BOARD ACTION REPORT – APPEALABLE ITEM

Project Name: Delray Beach Radiation Therapy Center
Project Location: 5270 Linton Boulevard (Delray Beach Medical Center)
Request: Class IV site plan modification associated with the construction of a 38,520 square foot building on the east side of the existing hospital.
Board: Site Plan Review and Appearance Board
Meeting Date: August 10, 2016

ITEM: Delray Medical Center – Class IV Site Plan Modification, Landscape Plan, and Architectural Elevations Associated with the Construction of a 38,250 square foot radiation therapy building.

SHEET NUMBER
L1.02

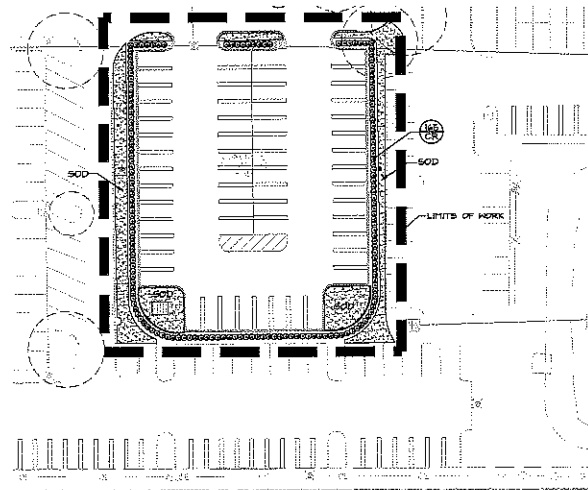
1. That a certified arborist report be submitted regarding the viability of relocating the native trees to other areas of the property and replace the proposed oak trees in the area of the proposed building prior to site plan certification. The relocation of these trees shall be subject to the approval of staff.

The new landscaping consists of Hong Kong Orchid trees, Gumbo Limbo trees, Southern Live Oak trees, Royal Palms, Montgomery Palms, and Mexican Fan Palms. The landscape areas will be under planted with Pitch Apple, Auntie Lou Ti Plant, Queen Emma Crinum, Red Tip Cocoplum, Croton, Green Island Ficus, Dwarf Podocarpus, Pink Muhly, Blueberry Flax Lily, and Dwarf Schillings Holly. The proposed landscape plan complies with the City's Land Development Regulations (Section 4.6.16) except the internal landscape areas identified below. However, the development plan identifies numerous trees that will be removed. These are comprised primarily of Live Oak trees. To the greatest extent possible, these trees should be relocated on the property. Consequently, a condition of approval is attached that a certified arborist report be submitted regarding the viability of relocating the native trees to other areas of the property and replace the proposed oak trees in the area of the proposed building.

ELEVATIONS

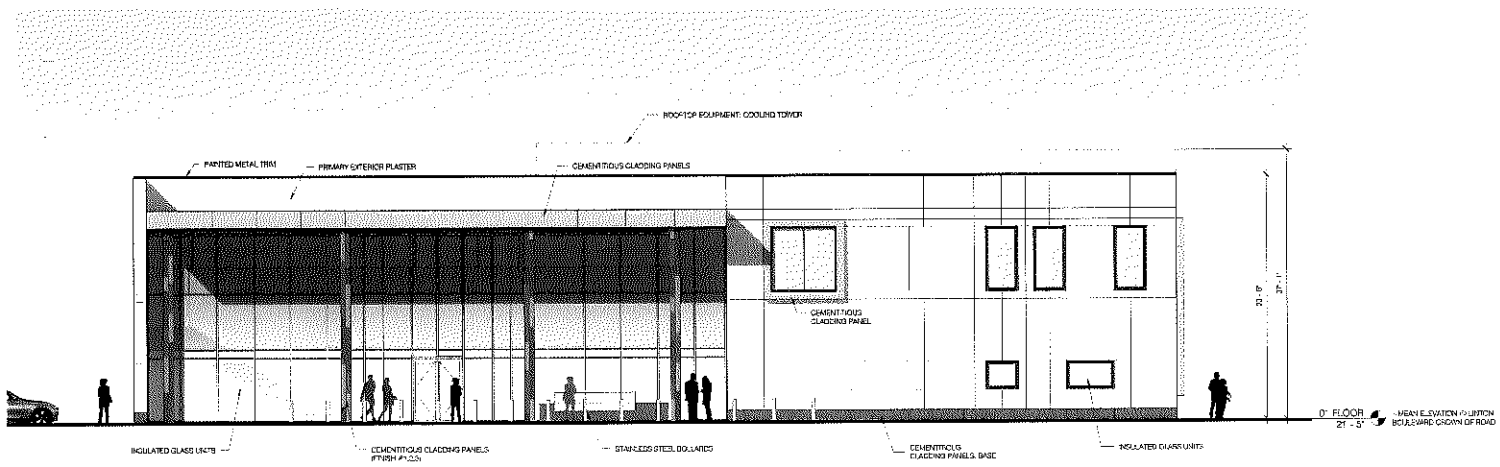
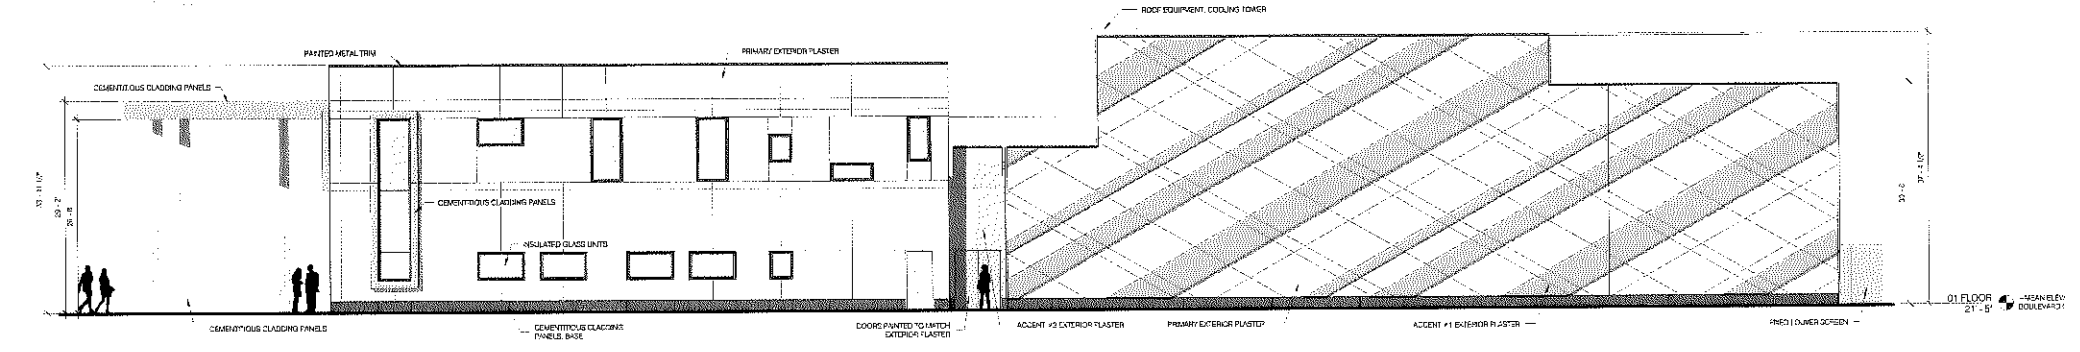
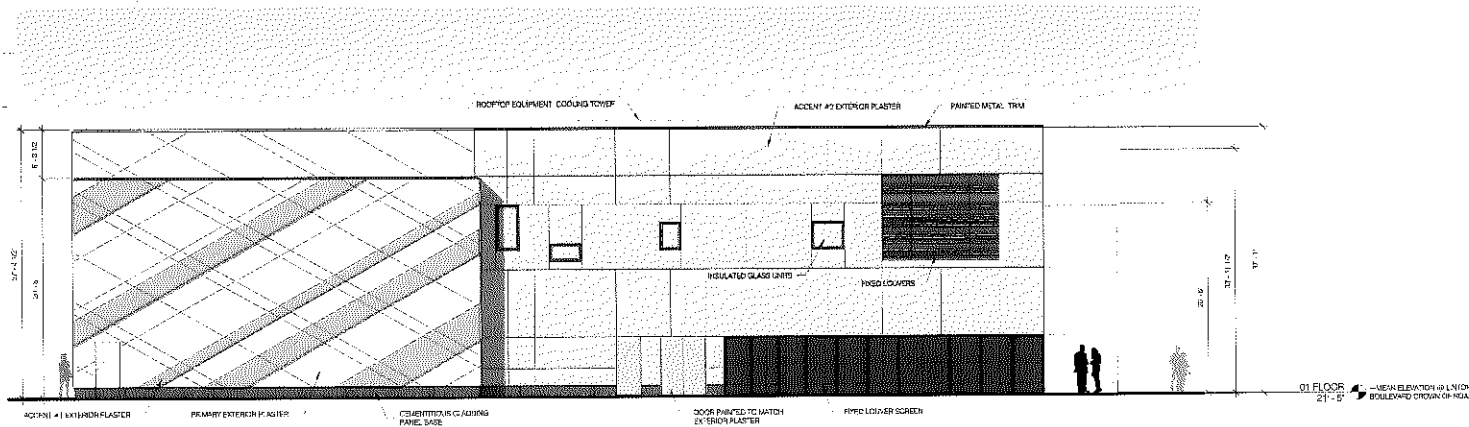
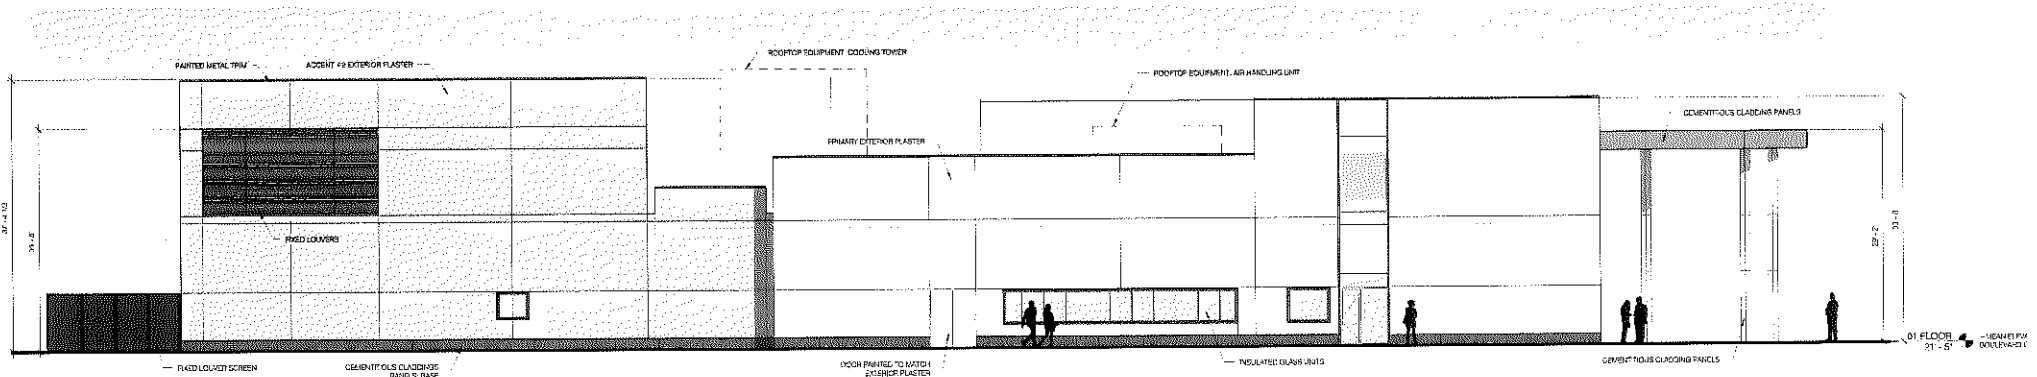
The architecture of the new building is contemporary. The building will have cementitious siding panels that will be painted gray. The columns of the porte cochere will have three variations of cementitious cladding panels. The east half of the building will have angled cementitious panels that will be painted light and dark gray. The modern design of the building is consistent with the existing architecture found on the hospital campus. Based on the above, a positive finding with respect to LDR Section 4.6.18(E) can be made.
